Section 96 Modification to Development Consent – SSD 5300 Kembla Grange Resource Recovery Facility Upgrade

The proposed modification to consent SSD5300 involves the installation of a larger demountable weighbridge office to service the new inbound weighbridge and the existing outbound weighbridge, and a slight realignment of the new weighbridge to be in line with the existing weighbridge. In the original design, a small weighbridge management office was to be installed adjacent to the new weighbridge, which would only service inbound vehicles. The proposed development will improve vehicle movement efficiency by ensuring that all weighbridge management occurs within a single office between the weighbridges.

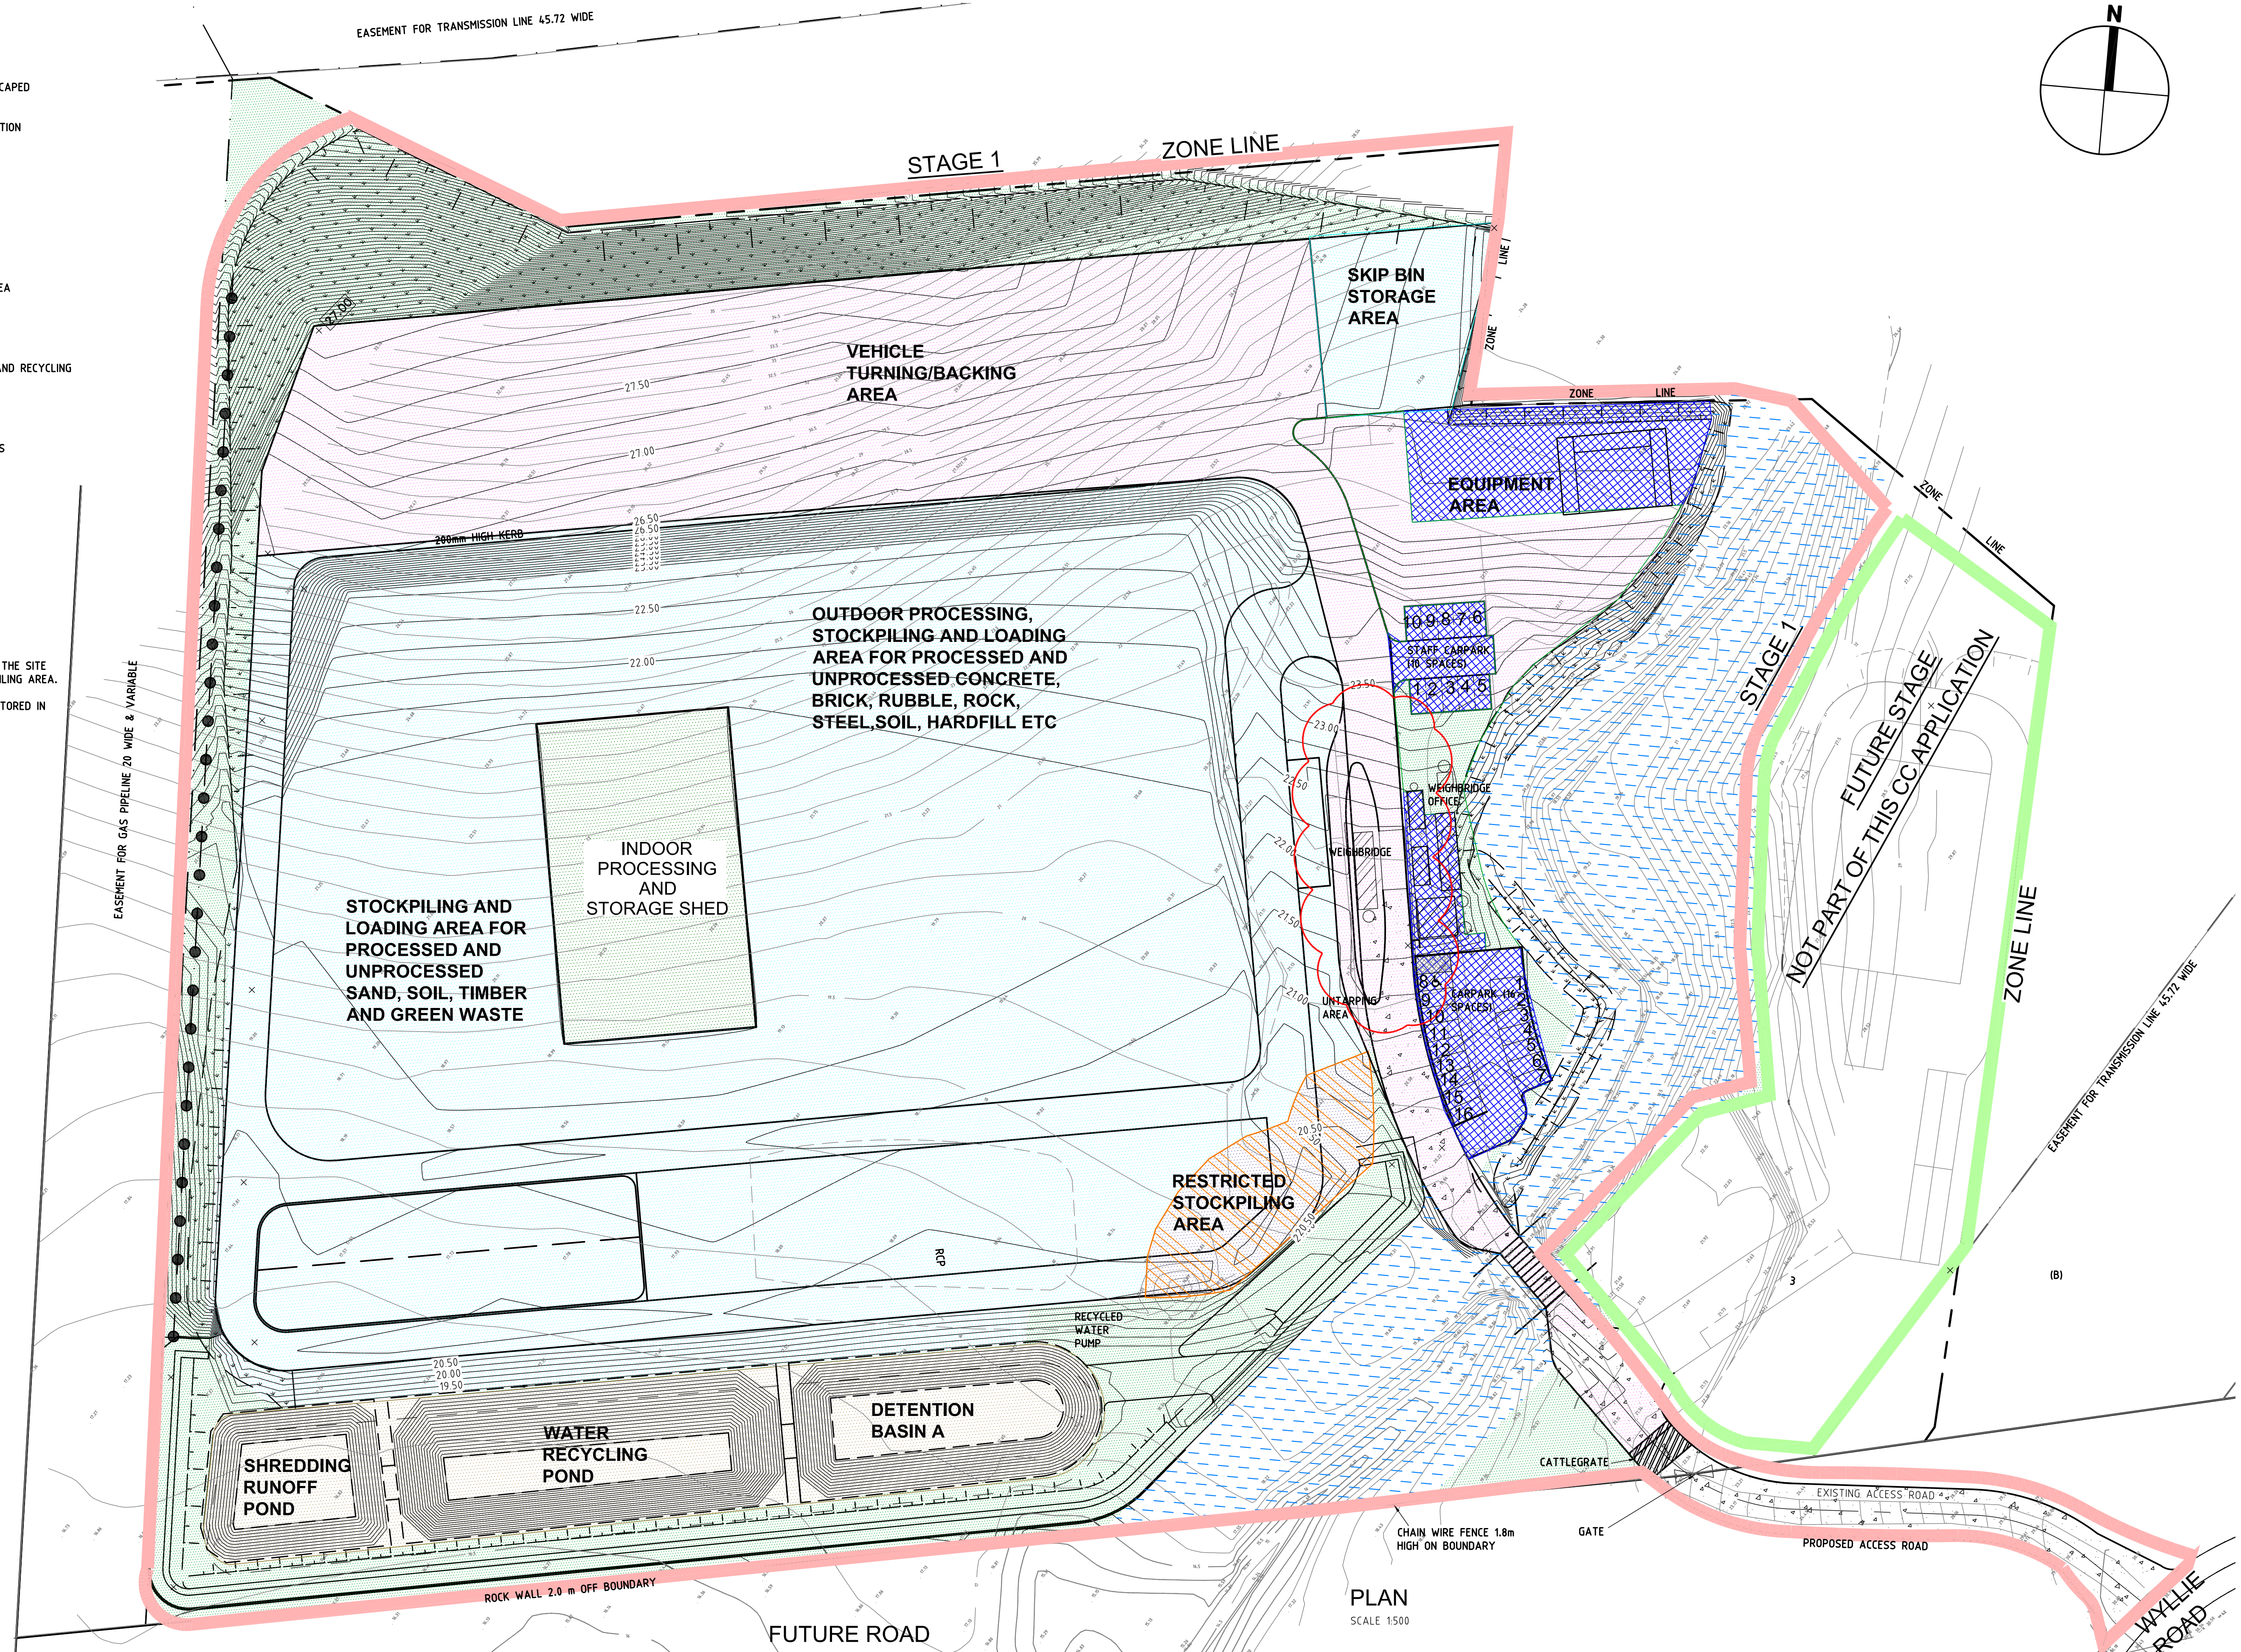
A	WEIGHBRIDGE LOCATION AMENDED	24.01.2017	B.M	W.M
Revision	Amendment or reason for issue	Issue date	Drawn by	Authorised

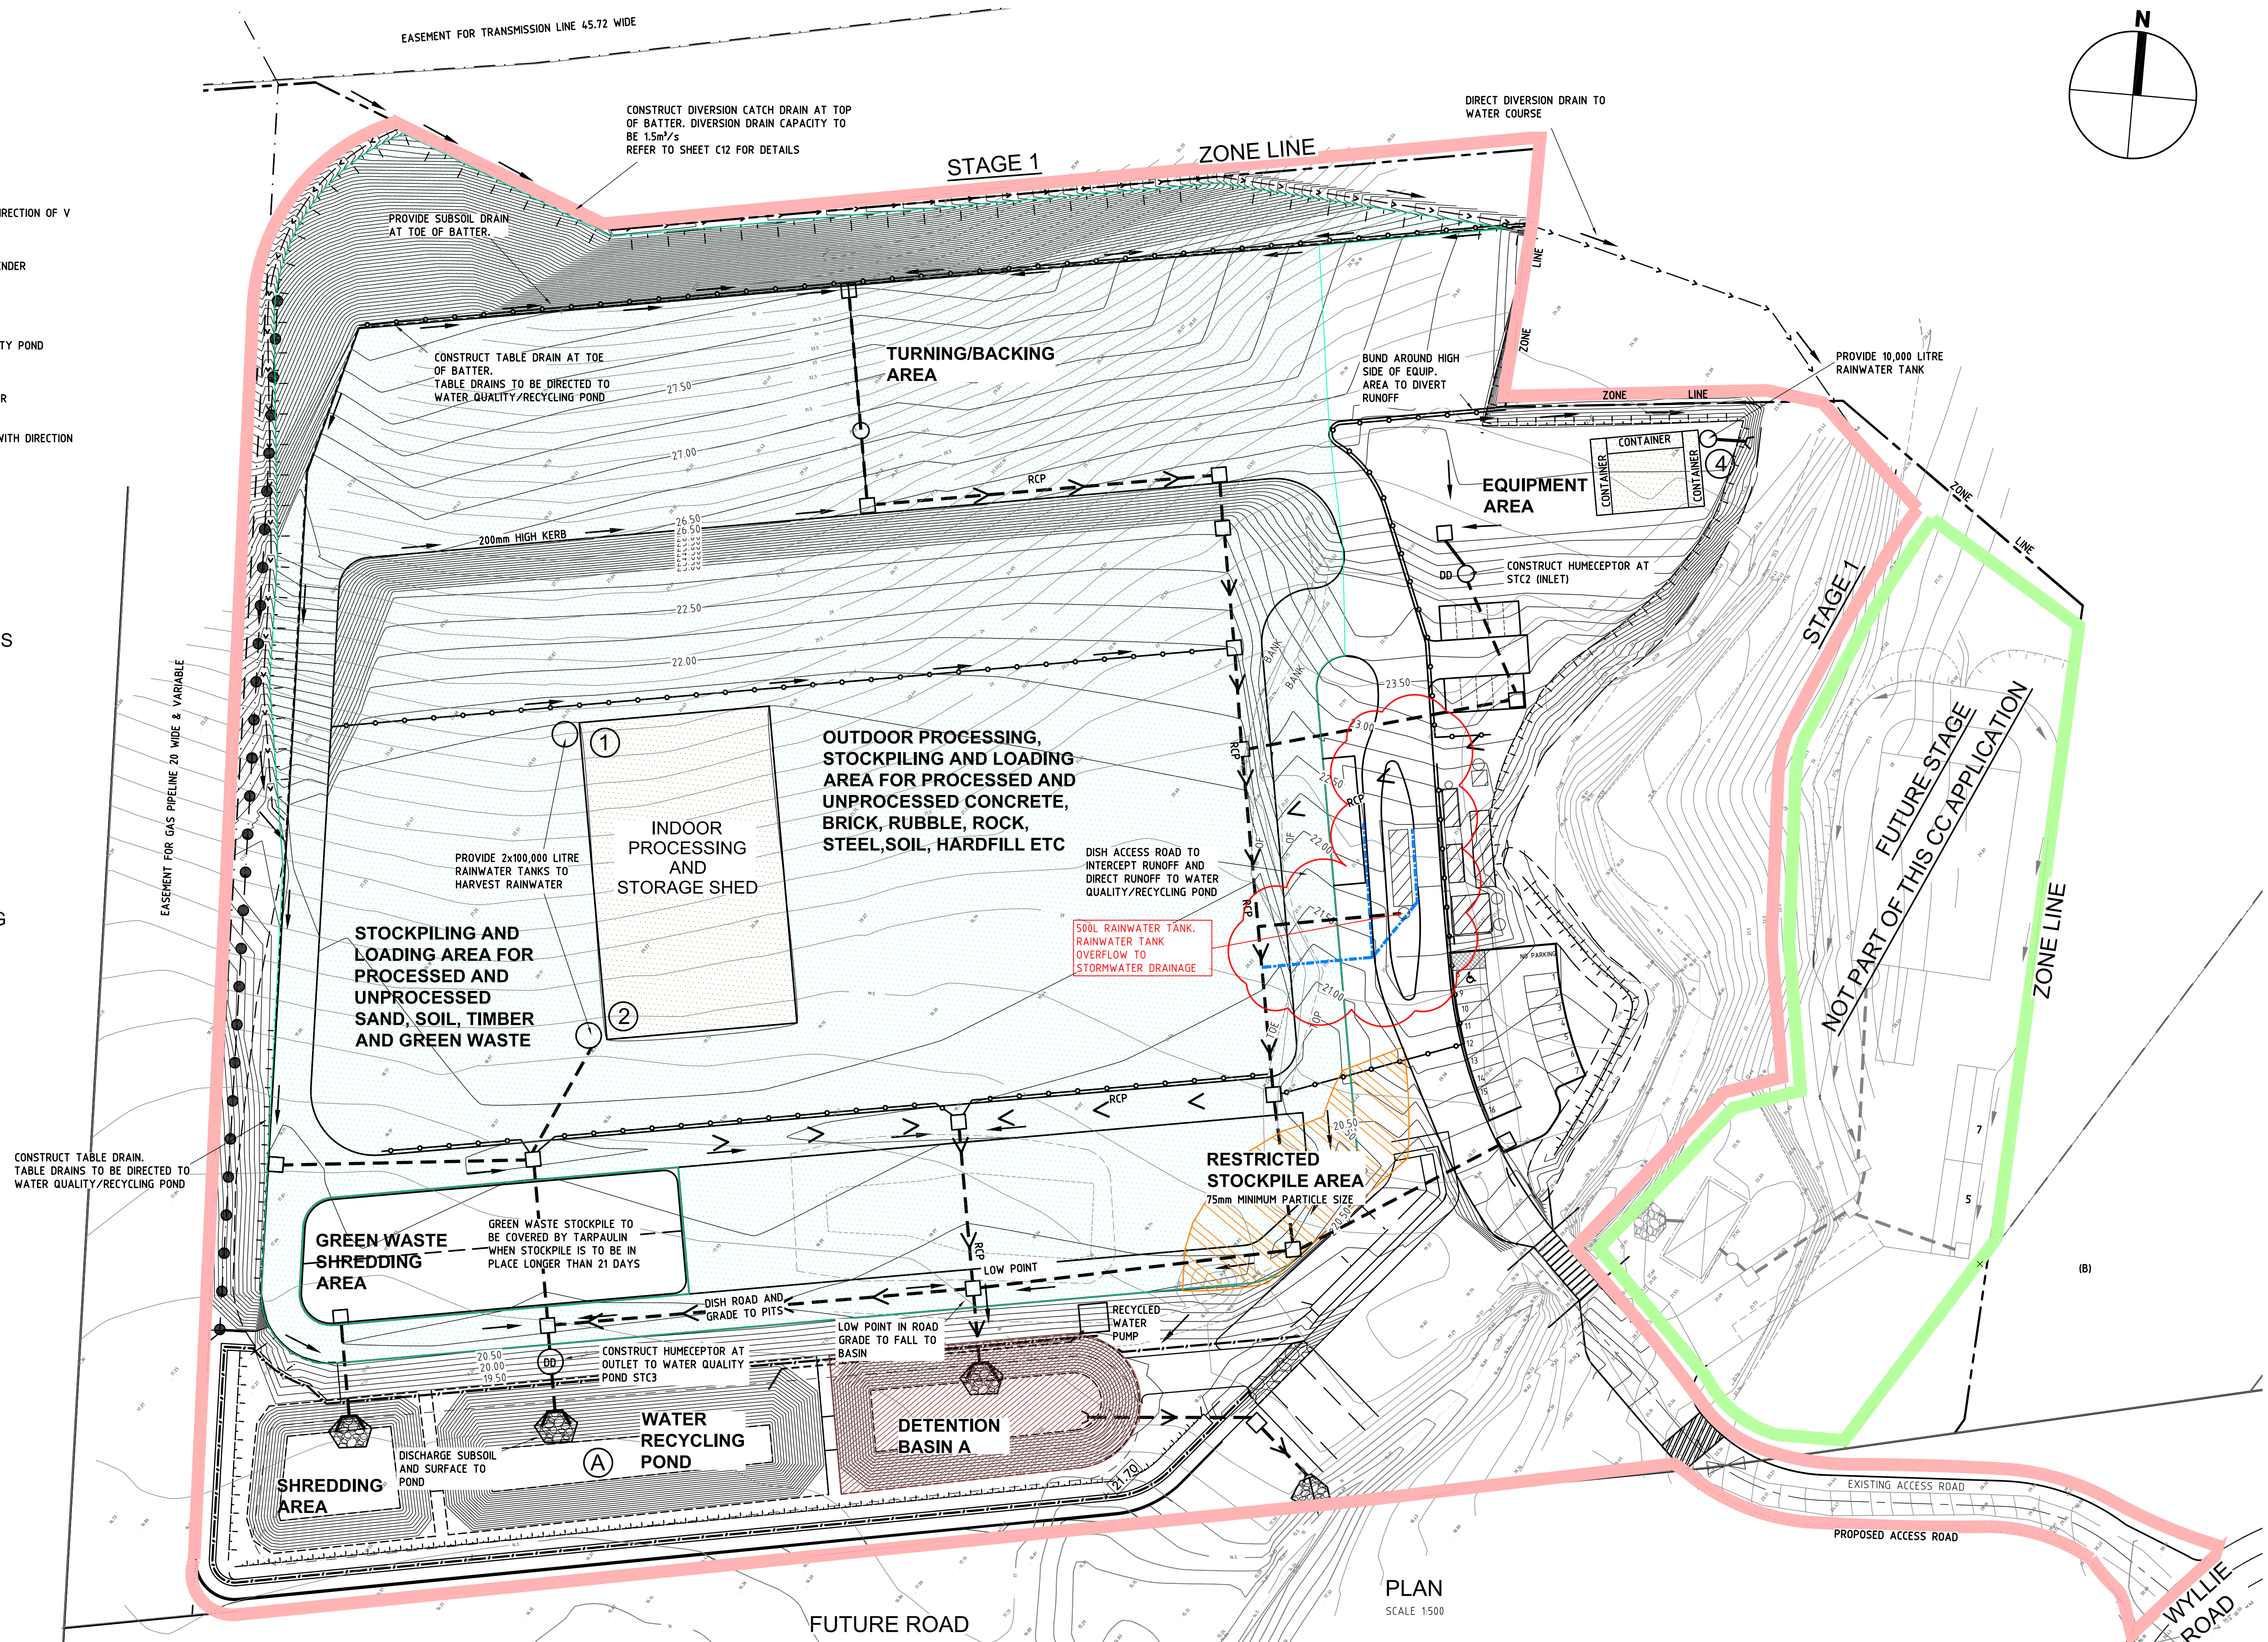
Revision	Amendment or reason for issue	Issue date	Drawn by	Authorised
A	WEIGHBRIDGE LOCATION AMENDED	24.01.2016	B.M	W.M

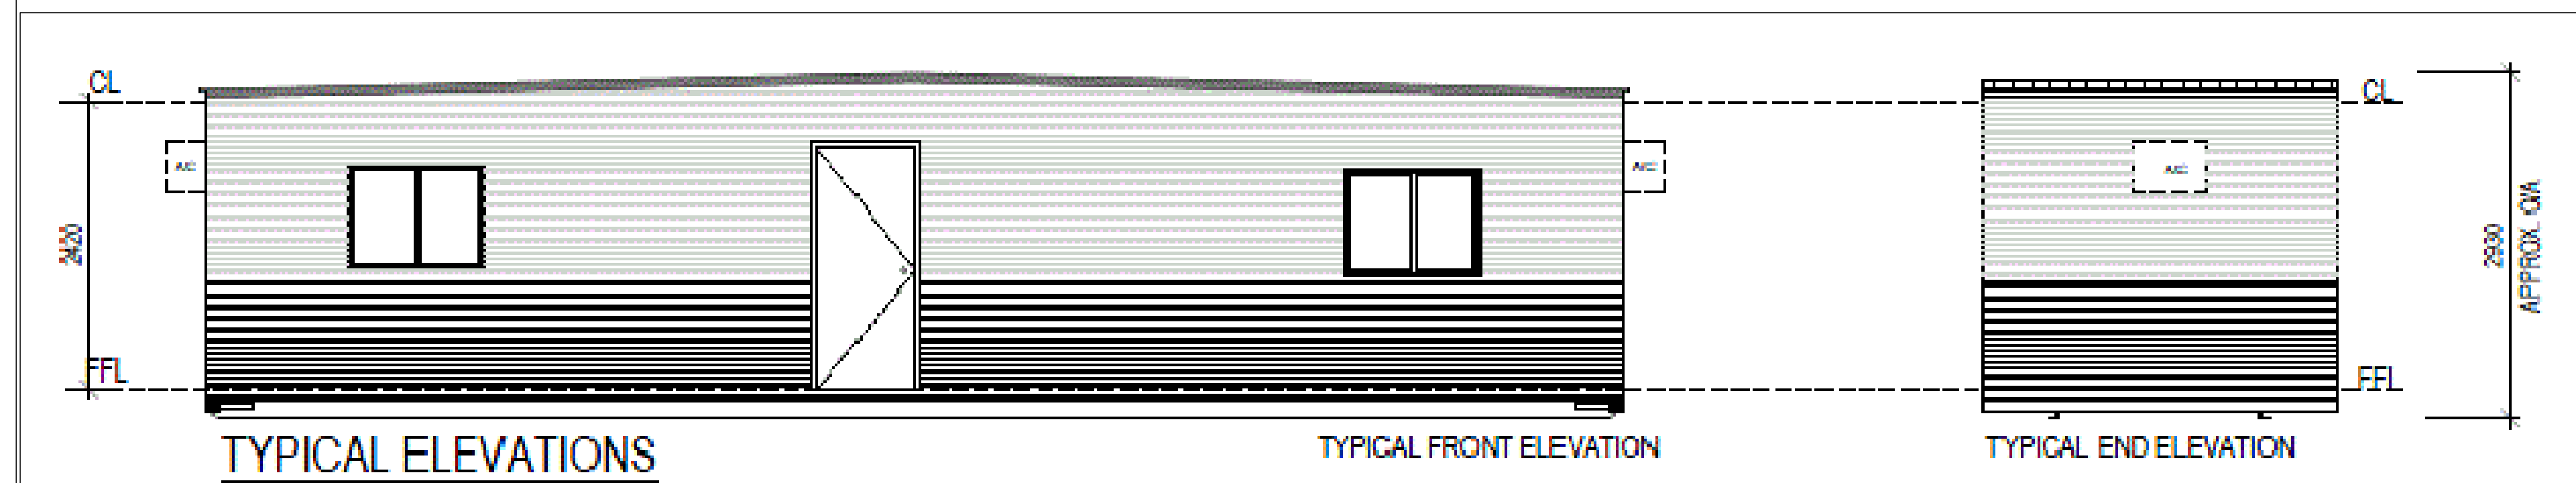
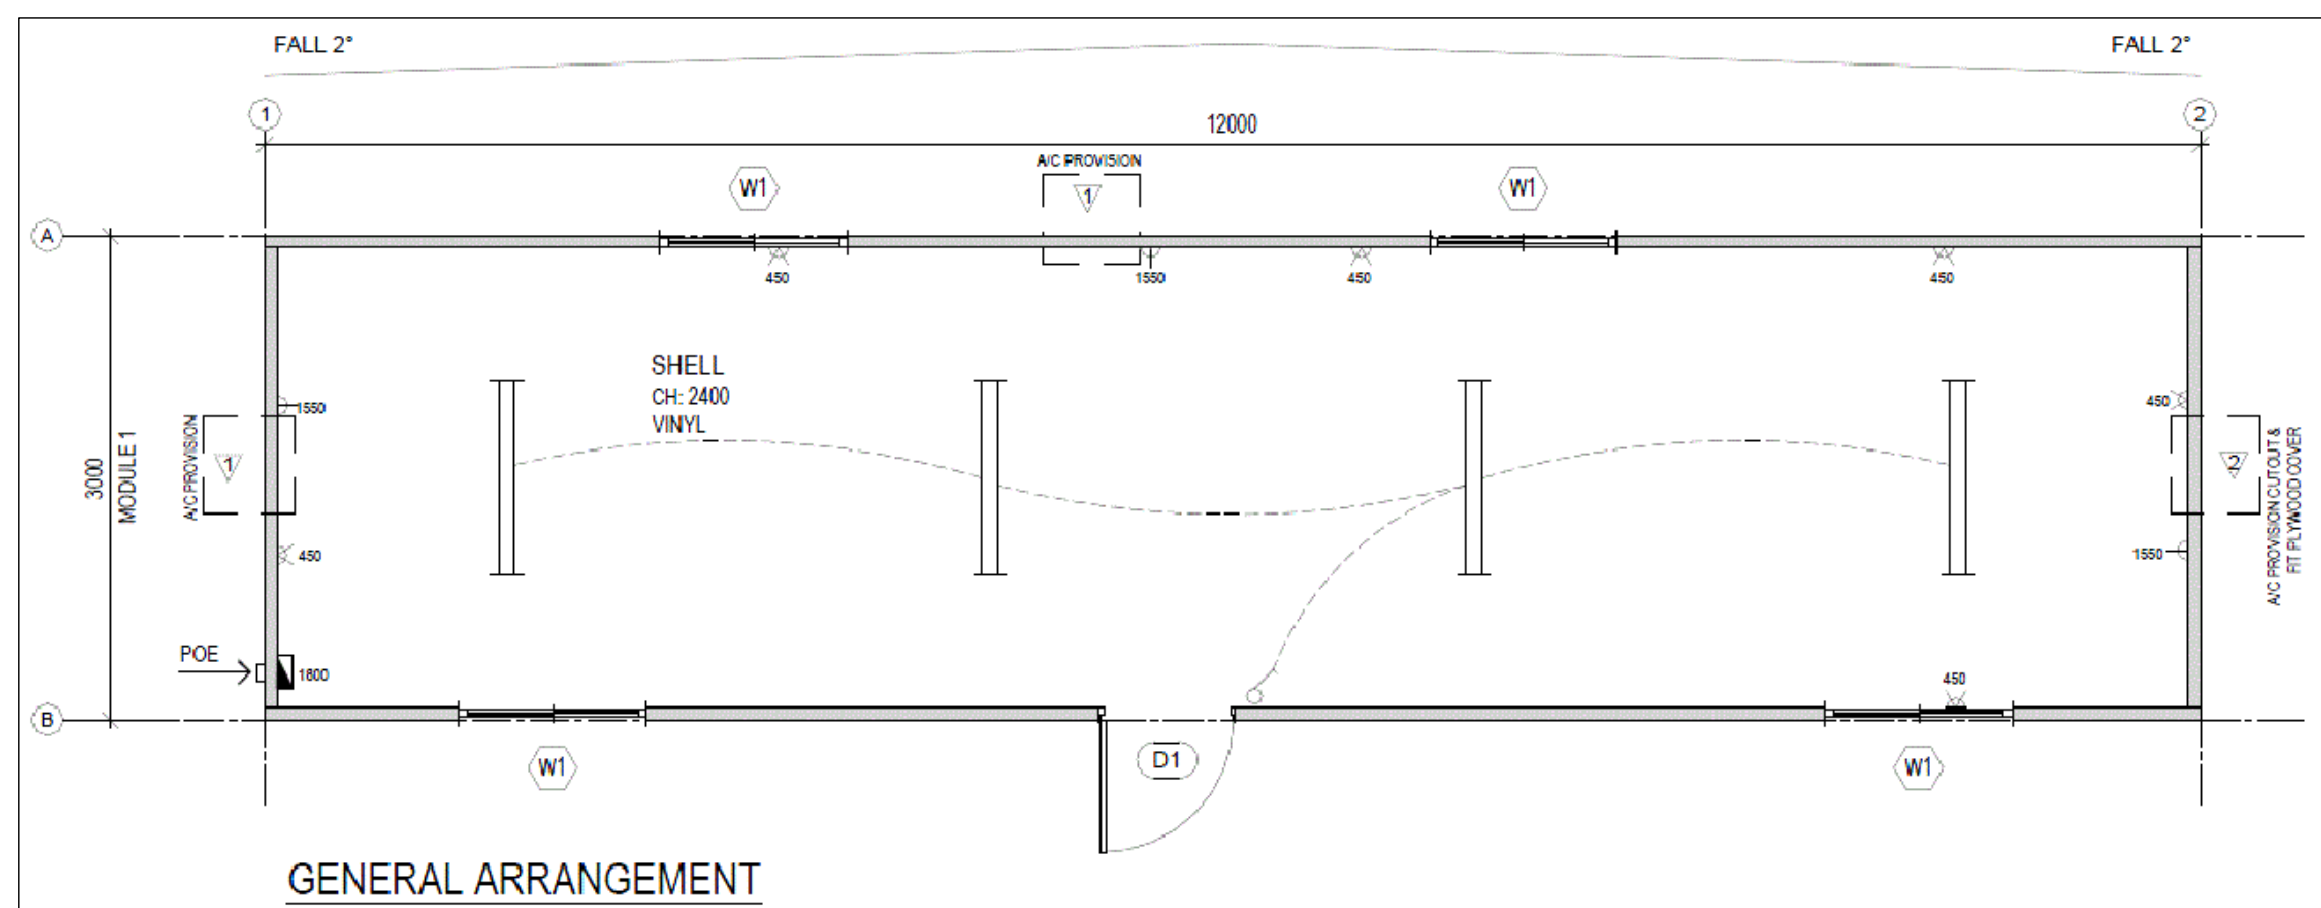
- Insert a demountable weighbridge office between the existing inbound weighbridge and the new approved outbound weighbridge (see amended Plans C320 / C301).

1. PAVEMENT FOR WEIGHBRIDGE APPROACH TO BE 400mm RECYCLED CONCRETE PAVEMENT.
2. THIS PAVEMENT TYPE WAS APPROVED UNDER SSD-5300
3. REFER TO SHEET C303 REV.A
4. NO CHANGES PROPOSED TO EXISTING ADMIN/OFFICE BUILDING AND CARPARKING AREAS
